SECTION **MA**

MODIFICATION NOTICE:

- SAE Viscosity Number charts for engine oil have been revised for Europe.
- Caution on the air cleaner filter installation for TB engine has been added.

SAE Viscosity Number

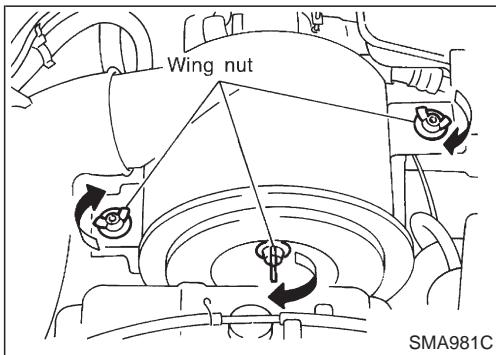
- 5W-30 is preferable. If 5W-30 is not available, select the viscosity from the chart, that is suitable for the outside temperature range.
